ESTIMATE SHEET						
Company Name:	MRMLLP					
Project:	Gulmohar Residency					
Work Description:	Extra Specs					
Flat No.	F 401 (A Janaki Ram Reddy)					
Prepared By	Srinivas N					
Date:	09-06-2024					
S No.	Item Head					
1	Extra Charges	Item Description	Quantity	Units	Rate	Amount
	Flooring	Concrete Beige Tiles 4' X 2' (Living, Dining, MBR , CBR, GBR and Kitchen	887	Sft	35	31045
		65% of 1360 Sft				
	Skirting	21% of SBUA of 1360Sft	71	Sft	35	2485
		Total				33530

GULMOHAR RESIDENCY

Details of Additions & Alterations

Flat No	401	Block no.	' F '
Flat Area	1360 sft	Type	Deluxe / Luxury
Buyer Name	Mr. A Janakiram Reddy & Mrs. Jyothi Reddy		
Phone No.		Email

Description		Direction	Owners & Developers :		Date	Promoted by	
WORKING PLAN-1360 Sft-A2 TYPE		N	Modi Reality Mallapur LLP		25.09.2020	Modi Properties Pvt Ltd	
			Project Name & Phase :		Prepared By :	Approved By :	
					Jayaprada	Soham Modi

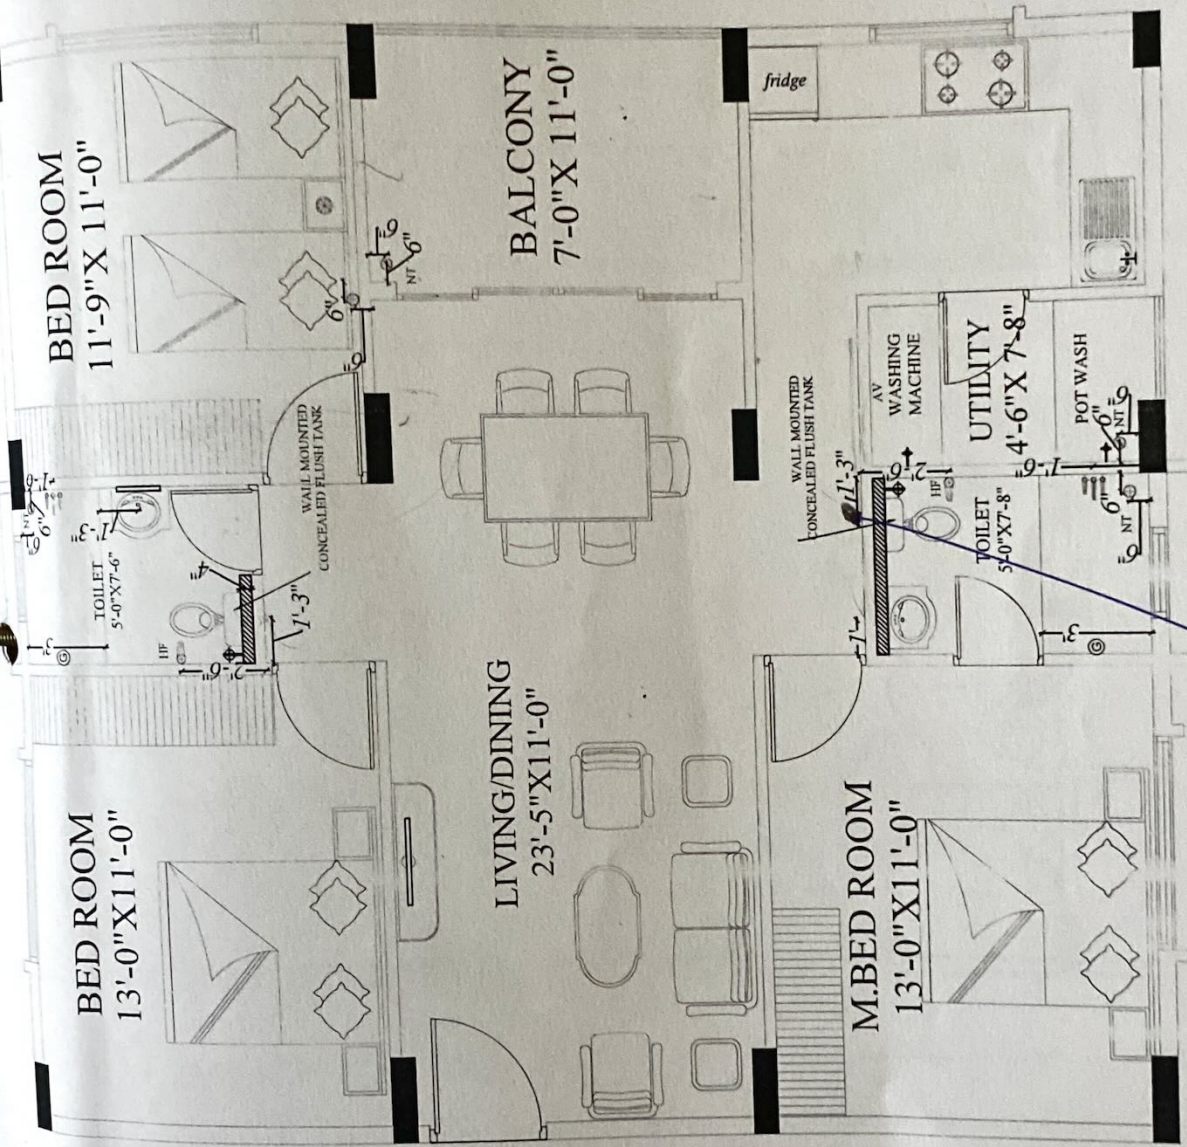
Changes in flooring:

① Customer will inform regarding flooring tiles.

② Big ^{Tile} ~~like~~ laying in Kitchen, dining Hall '3' Bed room

Extra cost

Description		Owners & Developers :	Date :	Promoted by
PLUMBING PLAN-1360 Sft (A2-TYPE)		Modi Reality Mallapur LLP	16.09.20	Modi Properties Pvt Ltd
		Project Name & Phase :	Prepared By :	
		Gulmohar Residency	Approved By :	
			Scale :	Phone: +91 90 66335551

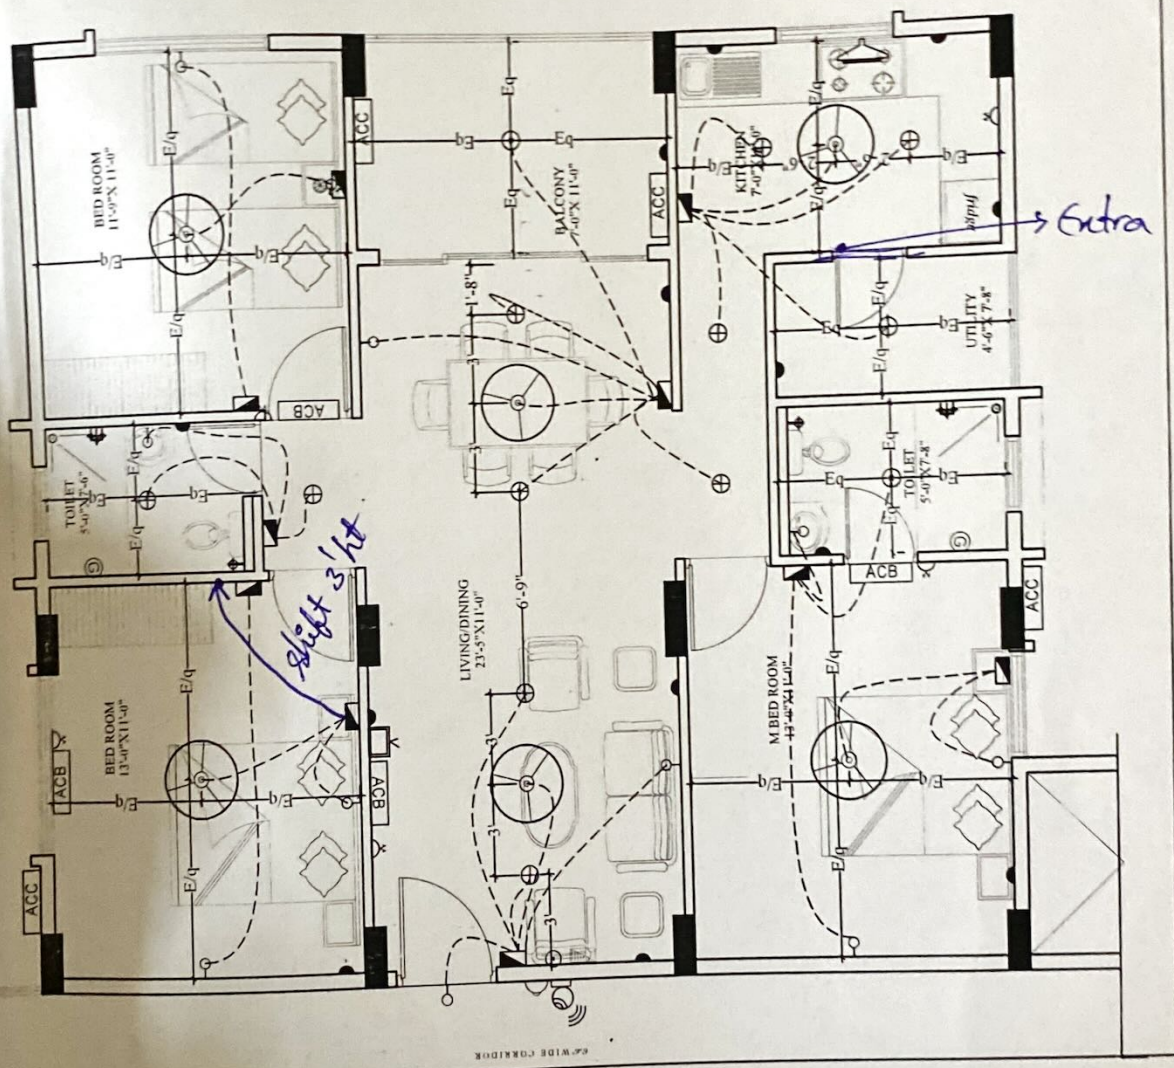
Extra 200 sq.ft
